**MONTGOMERY COUNTY PLANNING DEPARTMENT**  
THE MARYLAND-NATIONAL CAPITAL PARK AND PLANNING COMMISSION

**MEMORANDUM**

**SUBJECT:** Mandatory Referral No. 08106-MCPS-1: East Silver Spring Elementary School  
Addition Project – 631 Silver Spring Avenue, R-60 Zone, 2000 East Silver Spring  
Master Plan

# Attachment 3

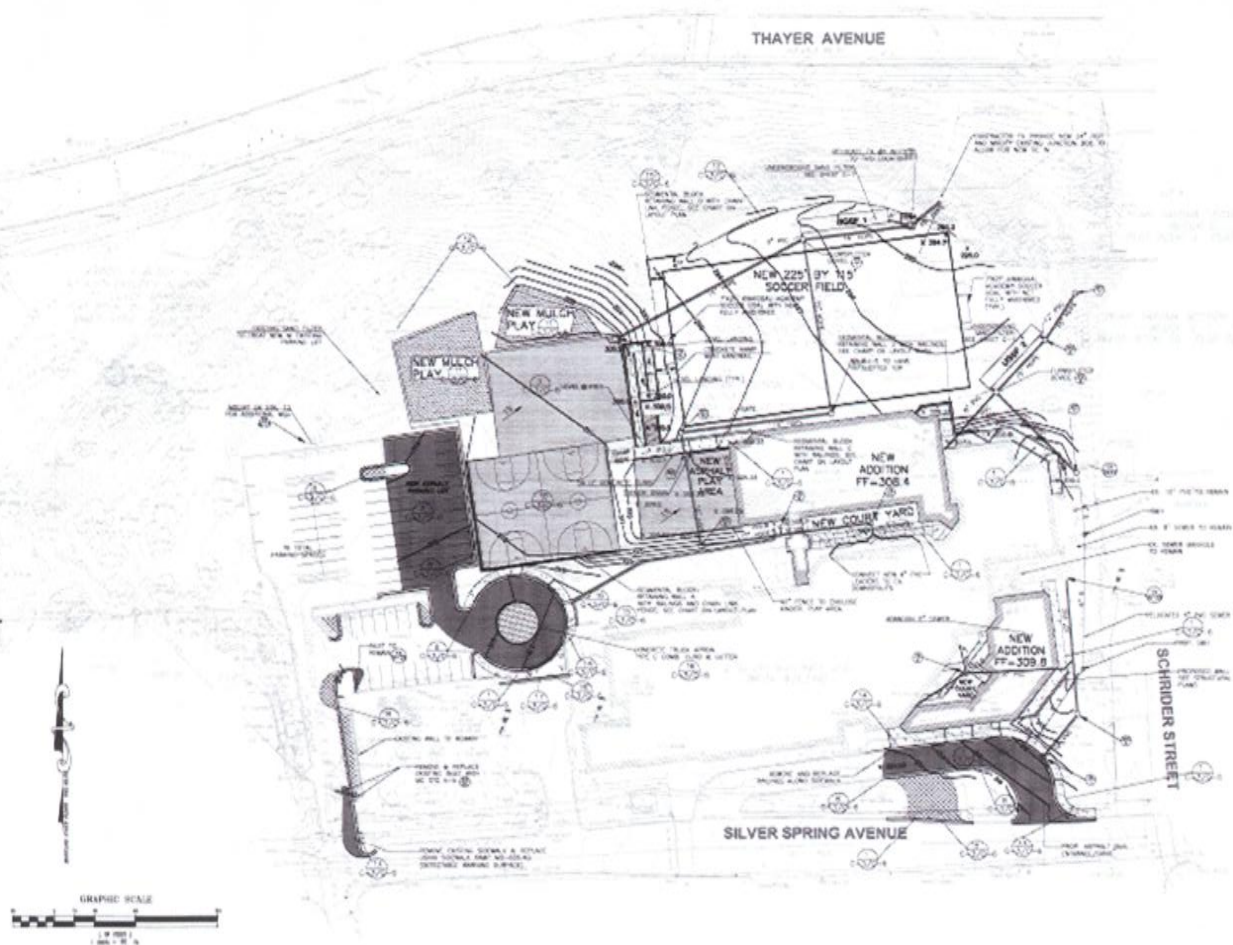
1. Any future mandatory referral submission for improvements at the school by MCPS must include a traffic study for Adequate Public Facilities (APF) purposes if those improvements will increase school's ~~core-program~~ capacity beyond ~~544~~ 538 students.
2. MCPS must discourage parent drop-off/pick-up of students along Silver Spring Avenue.
3. MCPS must improve sidewalk/pedestrian accommodation along the proposed new parent drop-off circle and improve lead-in walk accessibility from Silver Spring Avenue to the school entrance.

4. MCPS must coordinate with Montgomery County Department of Transportation (DOT) on improving curbing, on-street parking, sidewalk alignment, and handicapped ramps (at school driveways) along the Silver Spring Avenue school frontage.
